# REGIONAL REVIEW FINDING

ARC REVIEW CODE: R903061

**Name of Proposal:** Cedars Road Tract Solid Waste Transfer Station

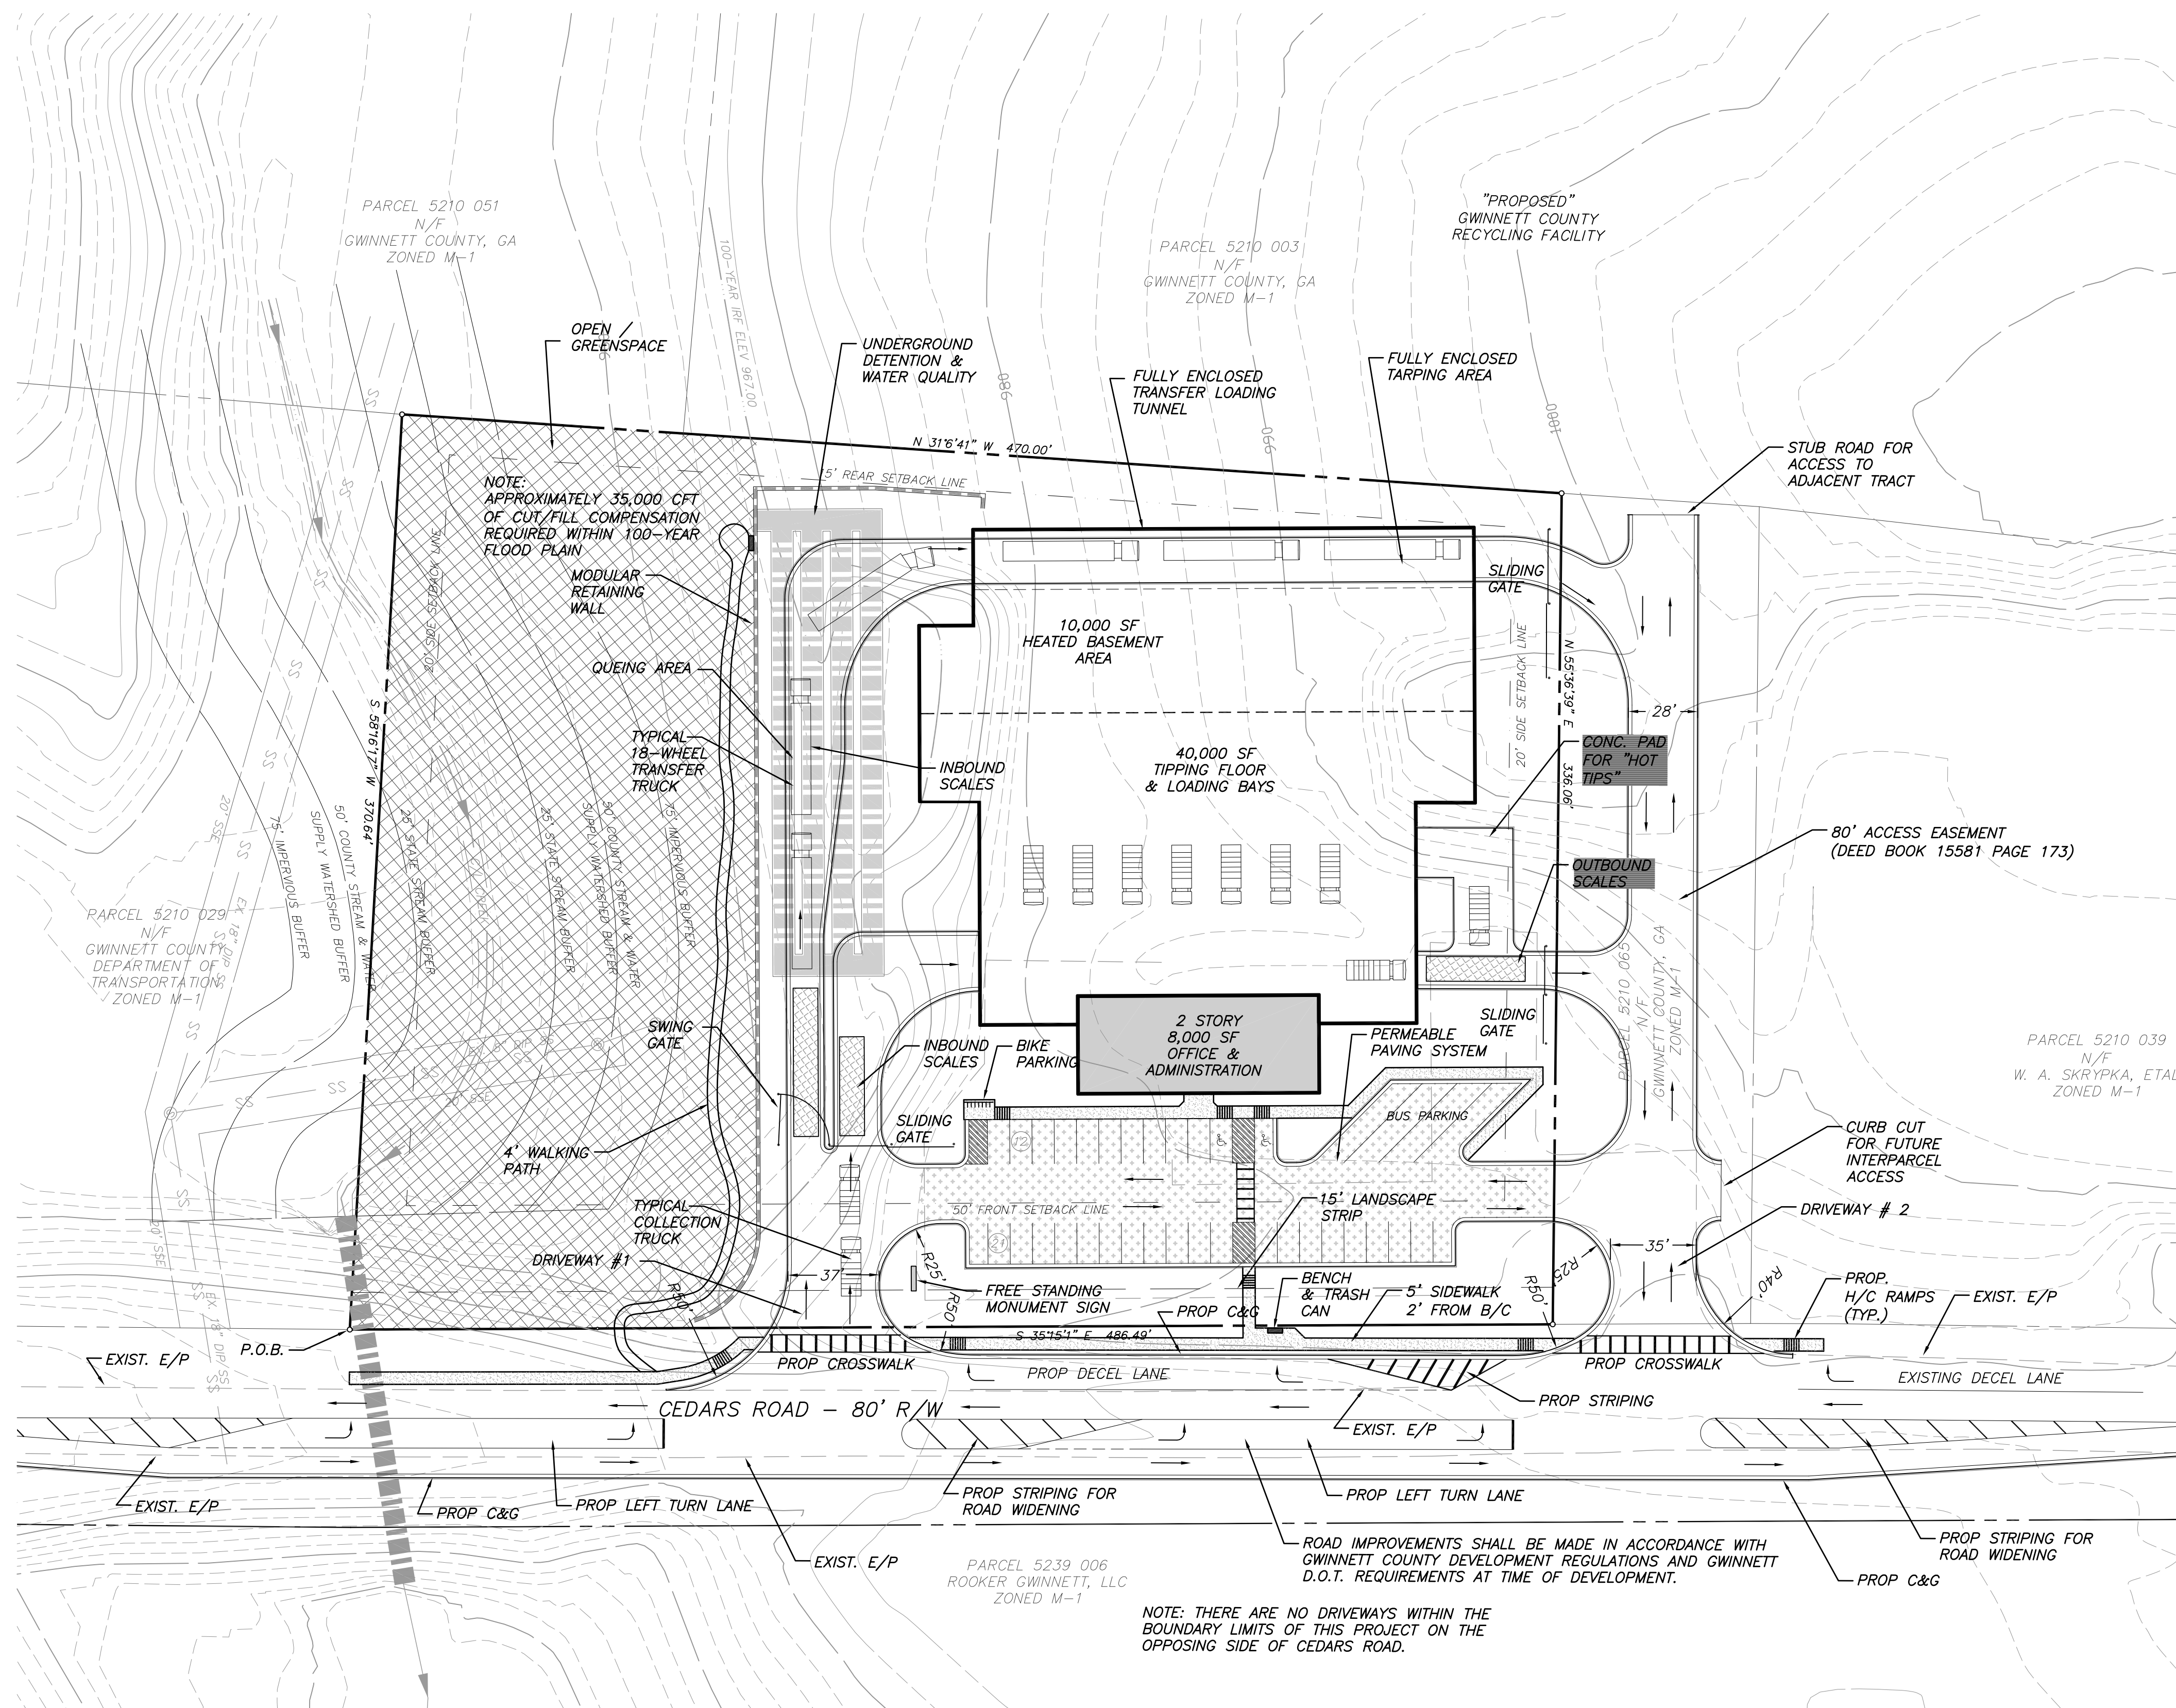
After the preliminary report was issued, the developer provided a letter (attached) which outlines his commitment to various site and access improvements for which the development was given credit in the checklist. The site plan (attached) was also revised to reflect these improvements.

- Section B Item 5.C: Please see the revised site plan. Bike racks have been added for this facility.
- Section B Item 5.F: Please see the revised site plan. Sidewalks have been added for this facility.

- Section B Item 5.H: Please see the revised site plan. A pedestrian bench, trash can and site access has been added to the streetscapes for this facility. Additionally, street trees and lighting will be provided in accordance with Gwinnett County's requirements.

- Section C Item 2.A: Please see revised site plan. The stream buffer and flood plain area will be established as open space.
- Section C Item 2.B: Please see revised site plan. All landscaping will be drought tolerant.

- Section C Item 2.E: Please see revised site plan. The automobile parking area will be constructed with a permeable paving system.
- Section C Item 3.A: The project will have a stormwater management plan that meets the requirements of Gwinnett County. This plan will maintain stormwater rates at or below design storm rates.
